QUESTIONNAIRE (s78) and (s20) PLANNING AND LISTED BUILDING CONSENT (Online Version)

APP/W9500/W/22/3301450

Land west of Highfield
Sled Gates
Fylingthorpe
North Yorkshire
YO22 4TZ

Highways Technical Note – Response to Highways Comments from North Yorkshire County Council

Drawing No. AMA/20940/SK005 Rev: -

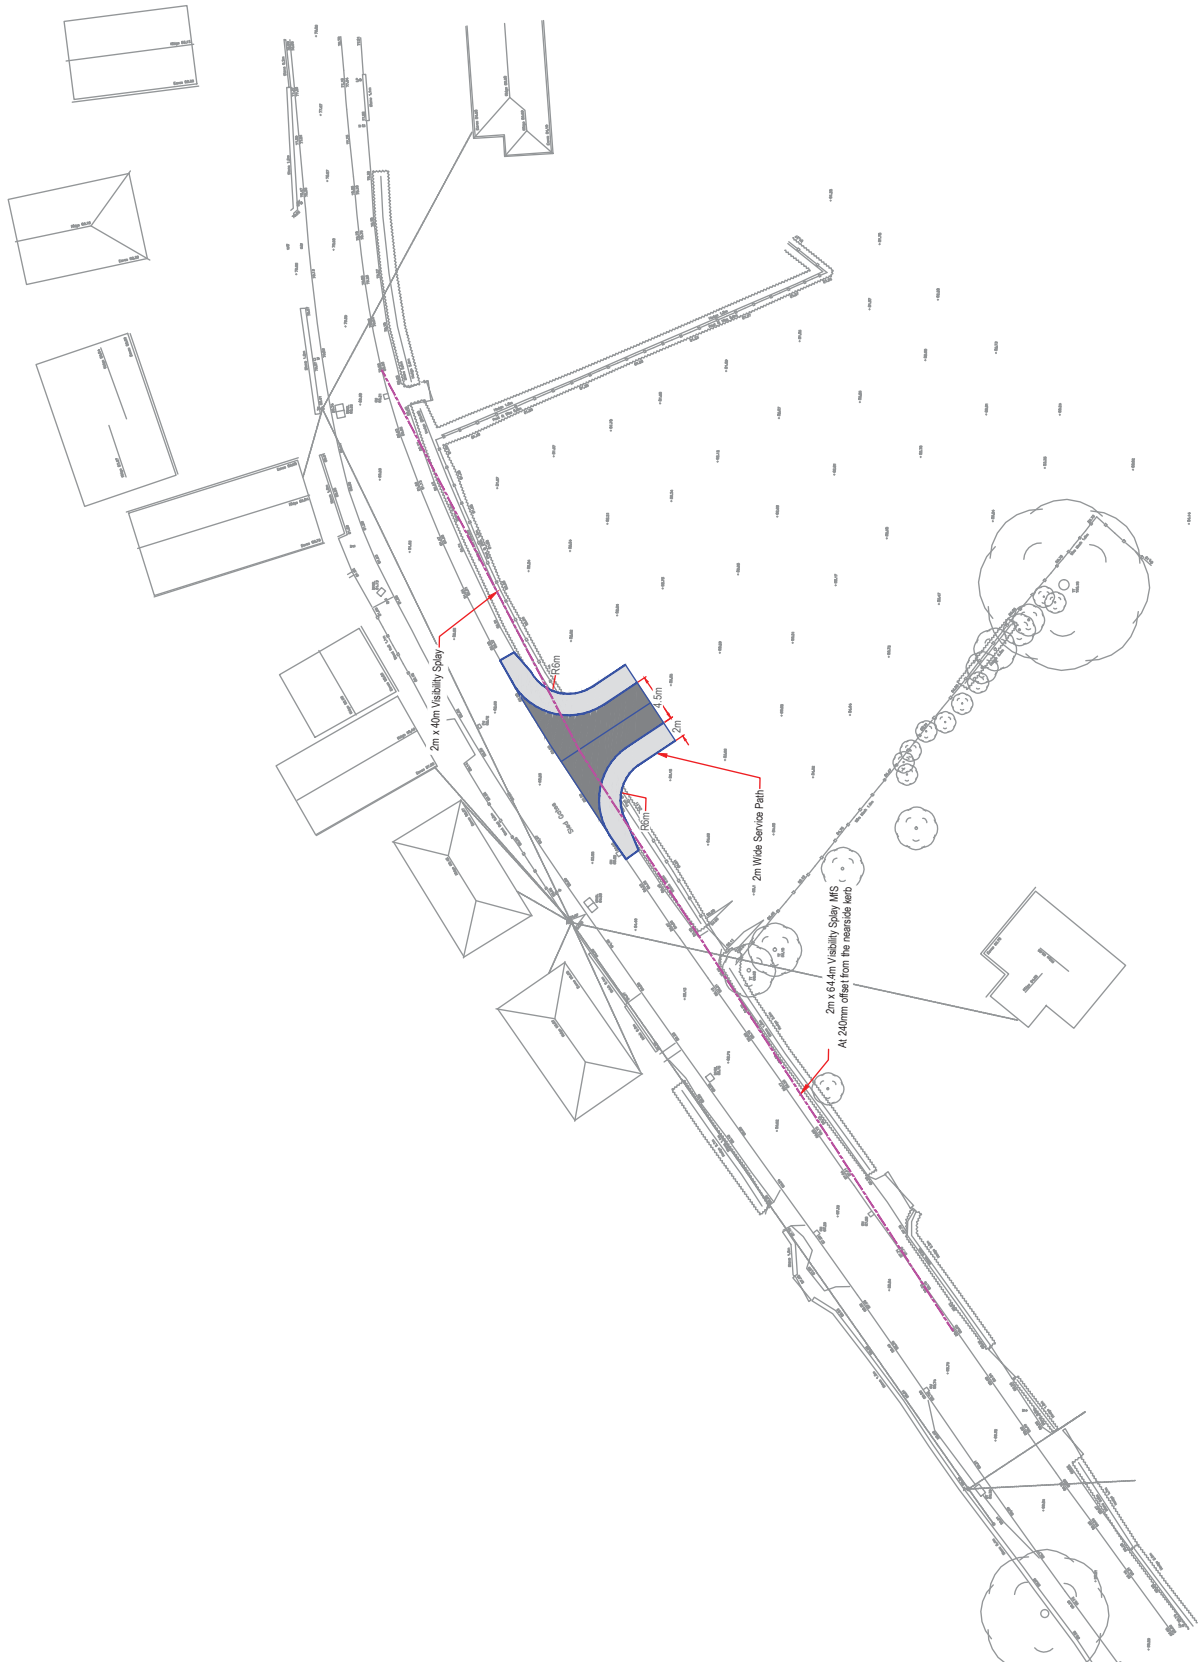
On the clear understanding that the work needed to make the alterations as shown on the plan will require removing the current hedgerow and wall at the back of the existing footway.

The figure of 36mph is taking into account a reduction of 2.5mph for wet weather reduction but the survey was carried out over 7 days, therefore this reduction should not apply.

The principal highways concern regarding this application is whether visibility splays can be achieved in both directions for the proposed access. The applicant has produced a revised drawing, nr. AMA/20940/SK004 dated 7/6/21 stating that splays of 2.0 x 58 metres to the west and 2.0 x 40 metres to the east are the maximum splays that can be achieved.

As per NYCC policy, given the site is for less than six dwellings and is a private drive a 2m setback is NYCC policy compliant. This is reflected in an updated visibility splays plan, SK-005, in **Appendix B** of this document. Further detail is provided in later AMA comments.

We have appended an updated visibility splays plan (SK-005) to this note based on a 64.4m SSD for the western visibility splay. This splay is offset from the nearside kerb by 240mm into the carriageway.

As detailed in the submitted Highways Supporting Statement, the average speed in this instance was 31.3mph and buses travelling at 90% would be 28.2mph. As such the SSD calculations provided in Comment 6 and shown on the updated SK-005 appended are more than sufficient to cater for bus stopping distances and are considered acceptable.
